CITY OF ALBUQUERQUE

Re: Playa Del Sur
99999 Miami Rd. NW
Conceptual Traffic Circulation Layout for DFT Approval
Engineer's Stamp 08-15-23 (H11-D075)

PLAYA DEL SUR
COORS AND I40
SITE PLAN

SHEET # SP-1
JOB # 2023024

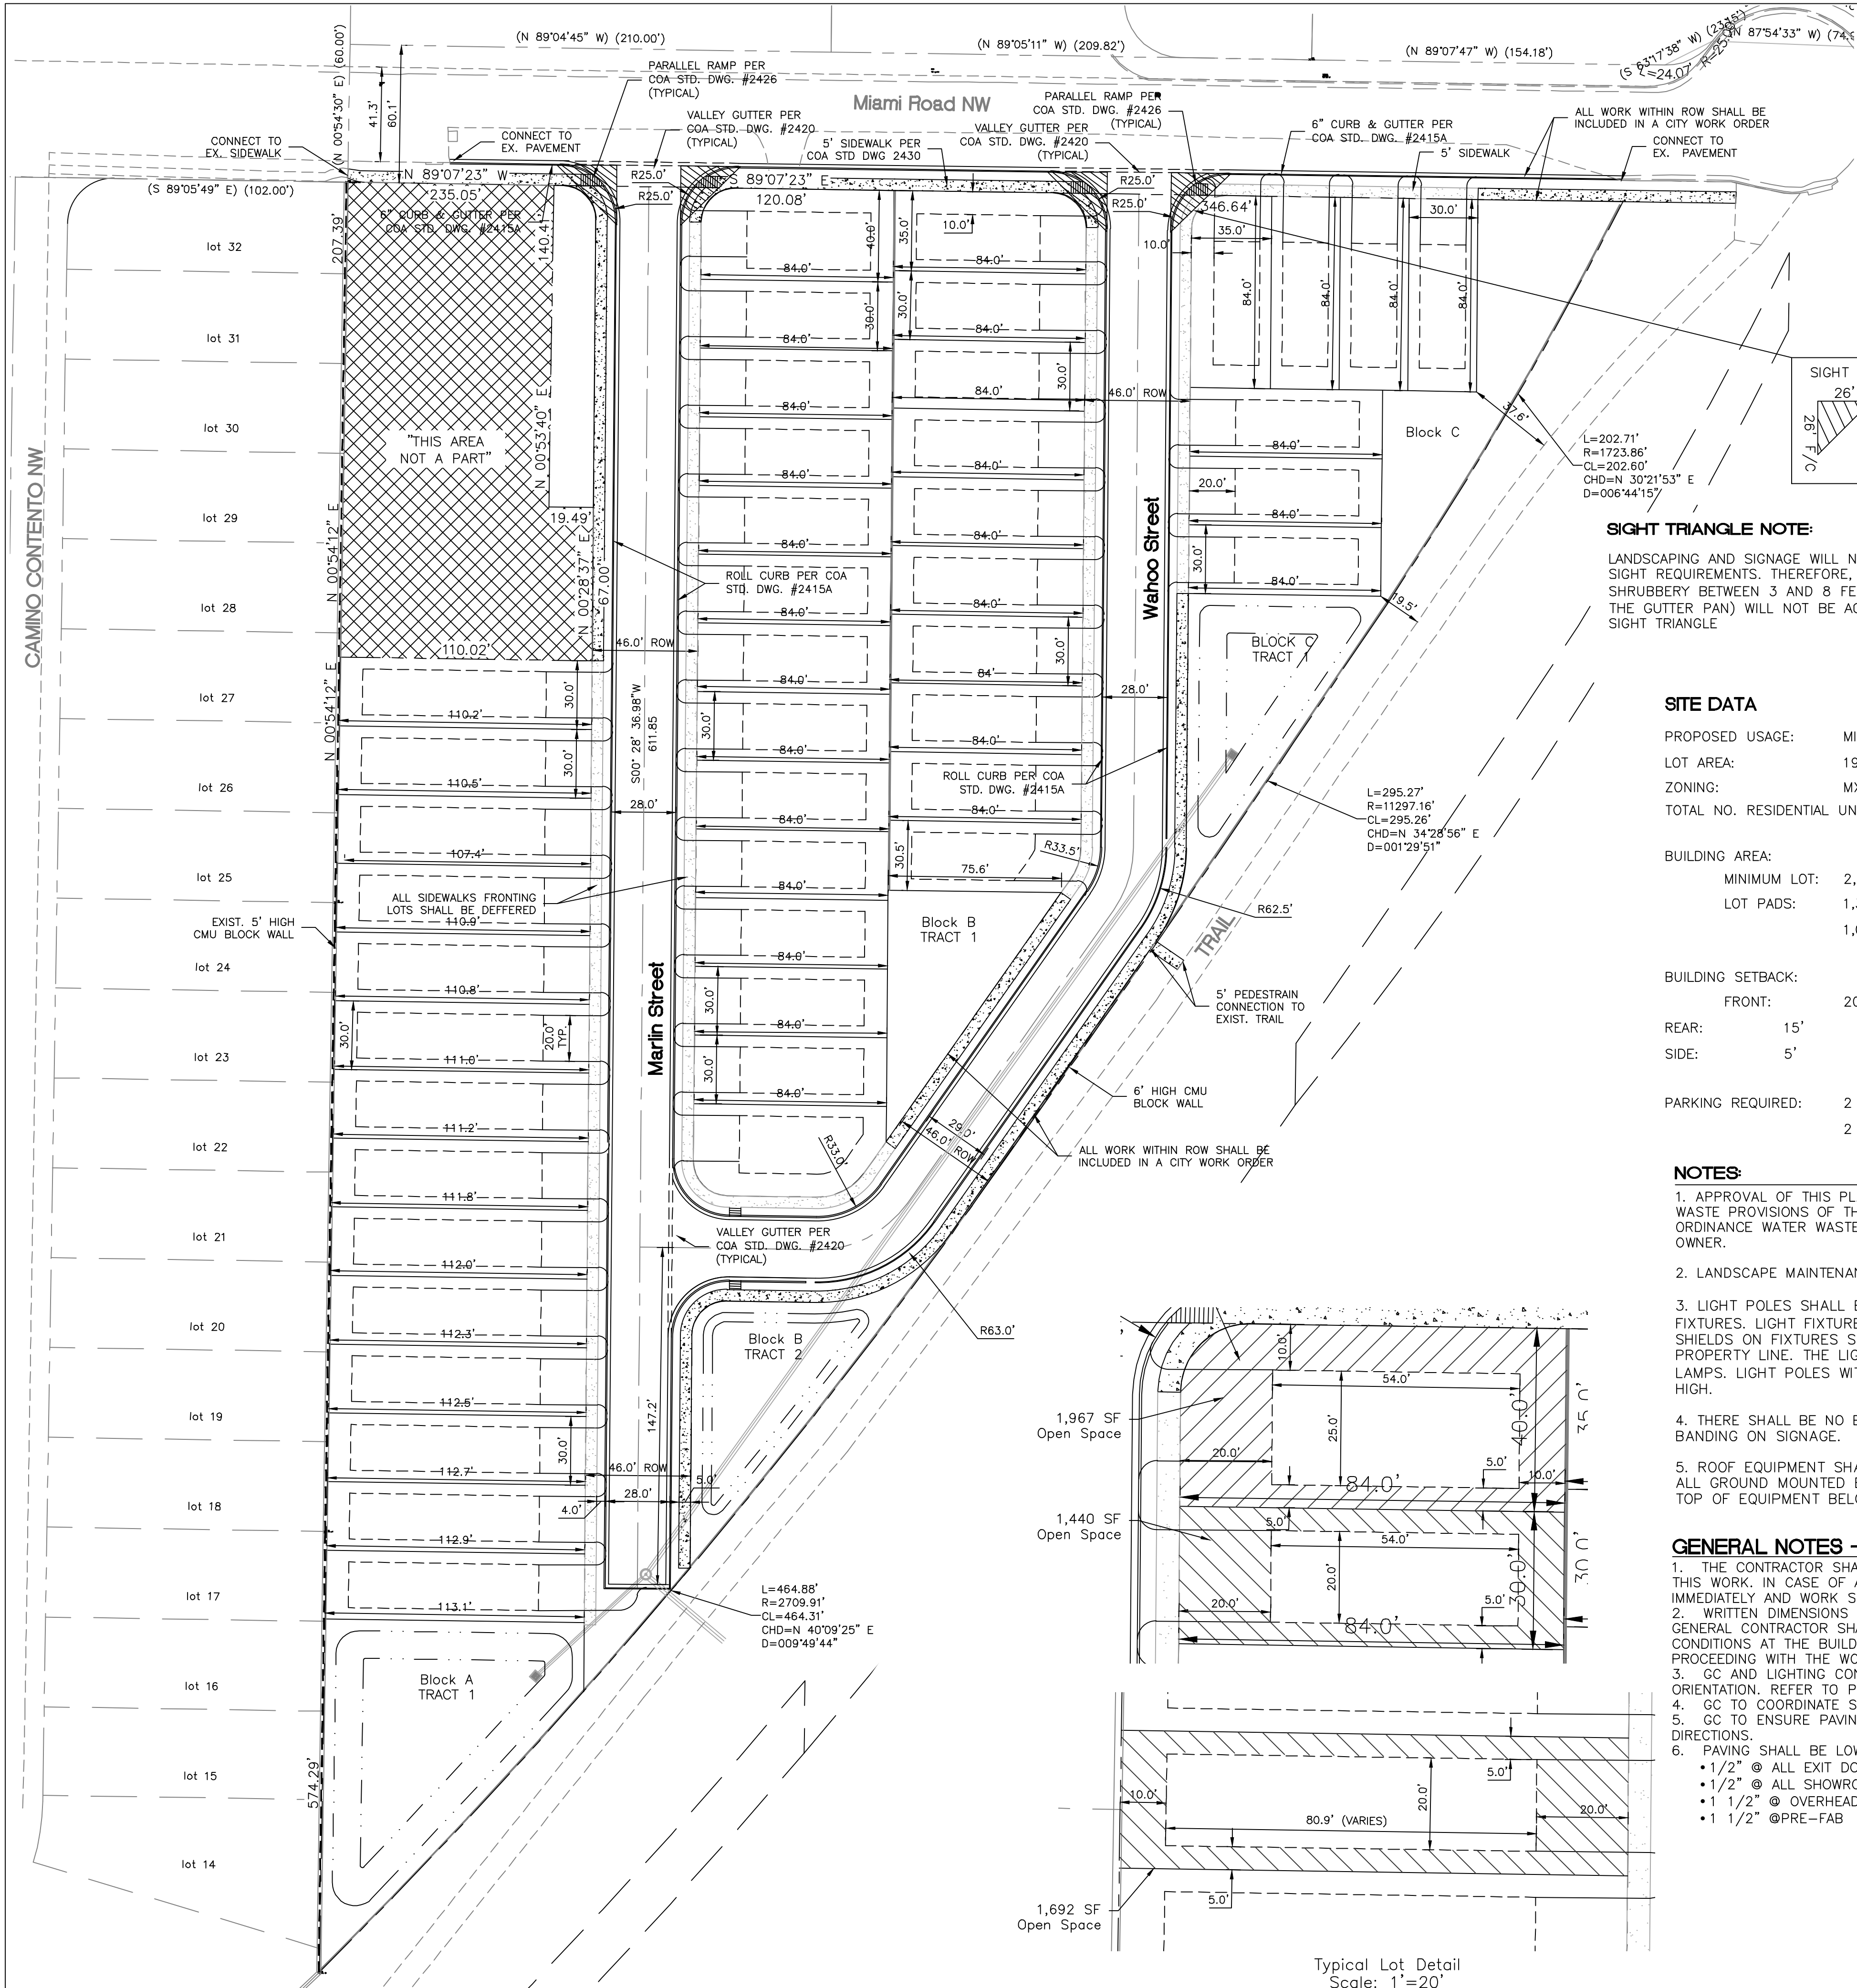
The conceptual TCL submittal received 08-23-2023 is approved for DHO and/or DFT submittal. When submitting this project through the building permit process, a full Traffic Circulation Layout will need to be submitted and approved prior to building permit.
